# Site Control Modification Manual 14H Update

December 2024 Planning Committee

### Manual 14H – Section 4.9.2

Exhibit 10: Generator Interconnection into Existing TO Substation

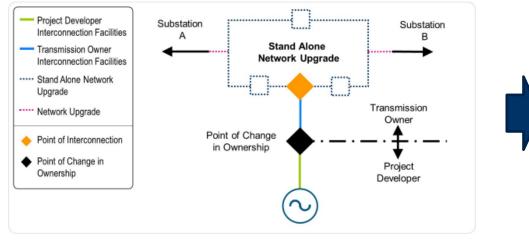
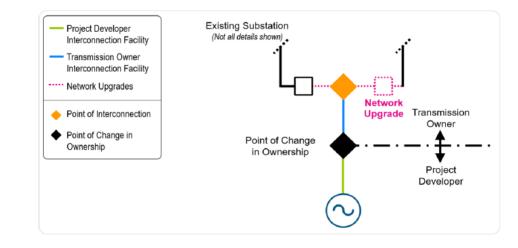
- In M-14H Section 4.9 shows diagrams of typical New Service Request Connection Types
- Exhibit 9 shows "Generator Interconnection via New Interconnection Switchyard"
- Exhibit 10 is supposed to show "Generator Interconnection into Existing TO Substation" but instead is the same diagram used in Exhibit 9

- PJM seeks to correct Exhibit 10
- PJM seeks to provide greater clarification on how Developers can meet tariff requirements for Site Control and what Site modifications are allowed under the tariff
- As PJM continues progress through TC1 and TC2 applications are due in Q4 2024, it is important for Developers to understand what Site Control modifications are allowed under the tariff in order to be able to continue to develop their projects and meet tariff requirements for Site Control at various points of the Interconnection Cycle process

Exhibit 10: Generator Interconnection into Existing TO Substation
